Palisades Nuclear Power Plant  
Docket 50-255  
License No. DPR-20

Request for Additional Information on License Amendment Request: Palisades' Spent Fuel Pool Crane Upgrade

**ENCLOSURE 1**  
**REQUEST FOR ADDITIONAL INFORMATION ON SPENT FUEL POOL CRANE**  
**LICENSE AMENDMENT REQUEST FOR PALISADES NUCLEAR PLANT**

**EA-FC-976-01, CHARTS, "WIDENED RESPONSE SPECTRA  
FROM FARSI ANALYSIS"**

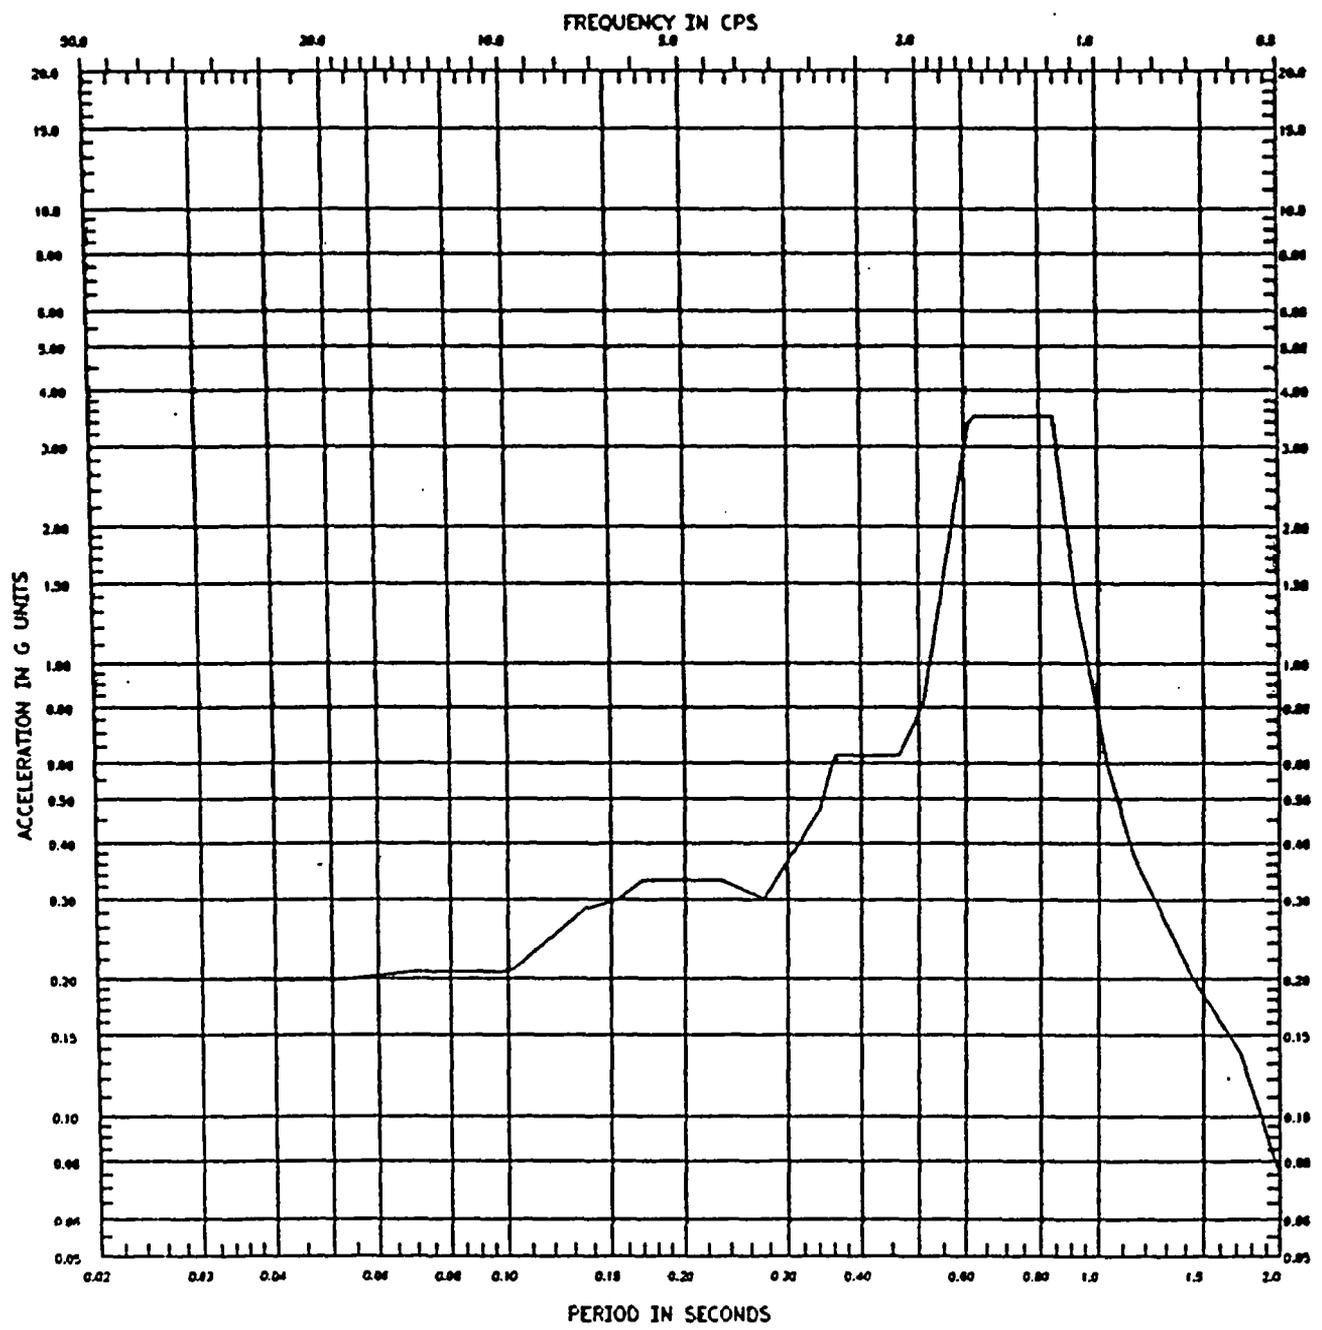
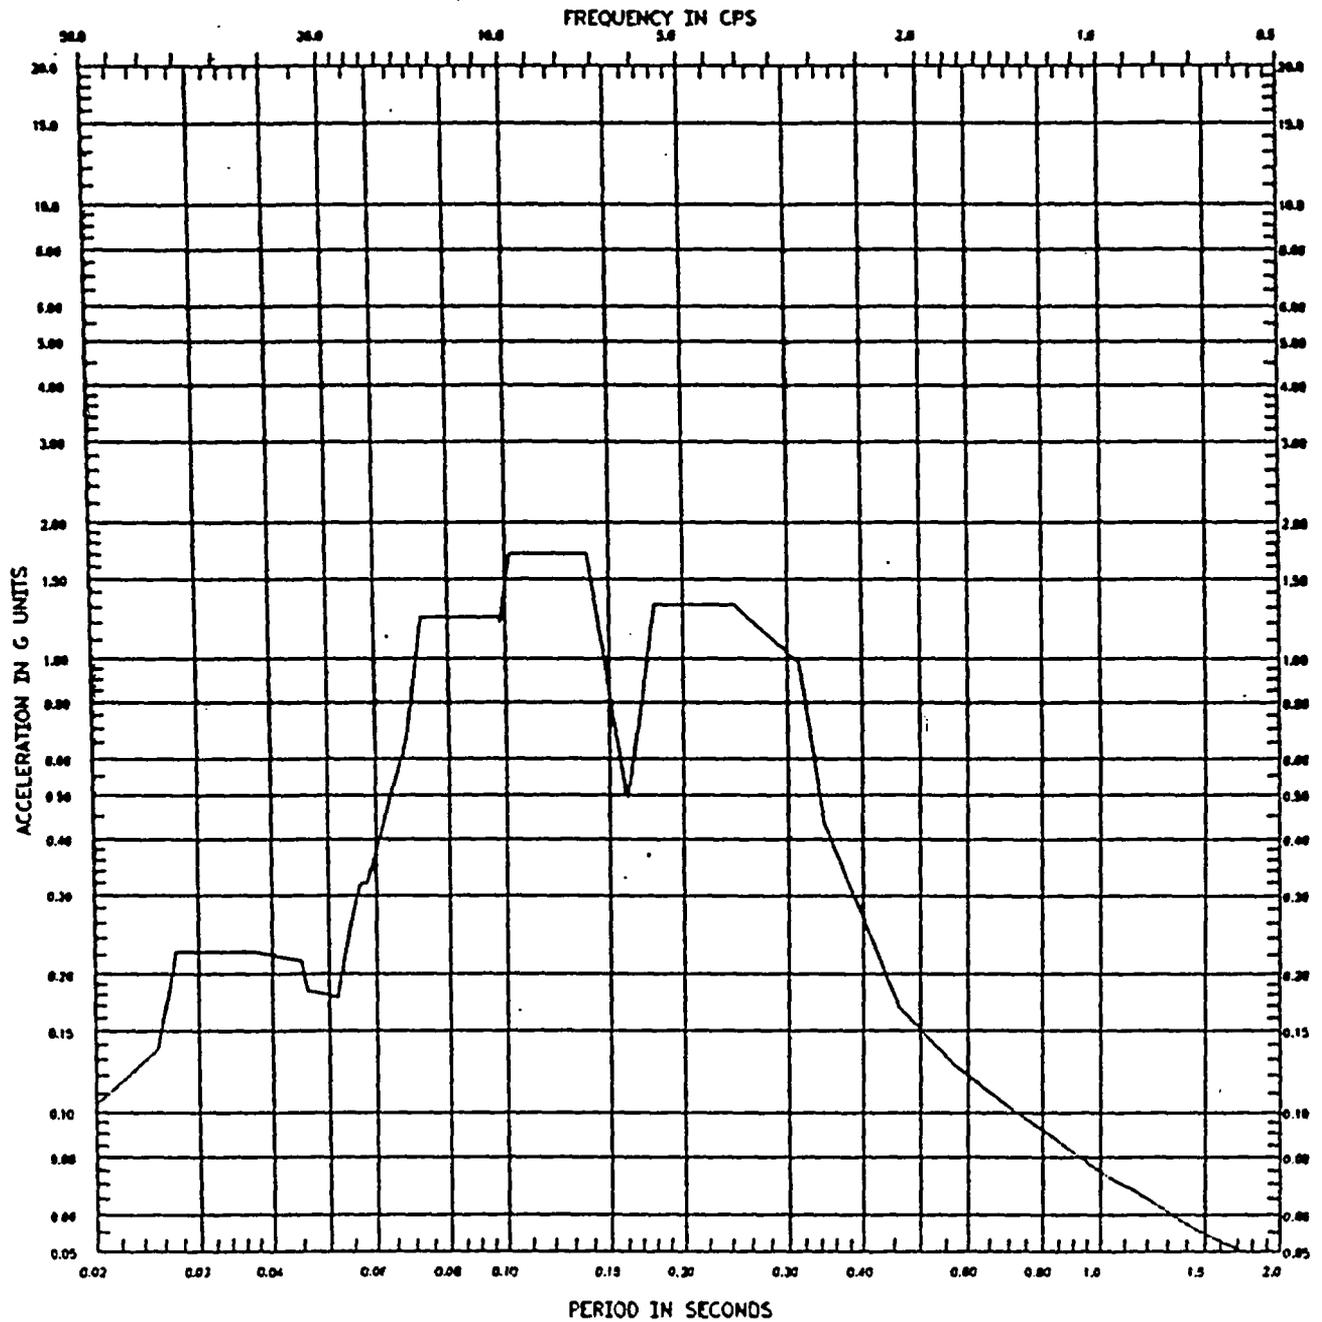
- 1. Provide a more detailed summary of the structural analysis for the upgrade of the spent fuel pool crane.*

The spectrums, in the three directions from the three hoist conditions, were enveloped and 15% widened. These spectrum are for North-South direction, East-West direction and Vertical Direction. The plots of the widened response spectra for the three directions are shown in Attachment 1. These response spectra are used as inputs to other analyses, as described below.
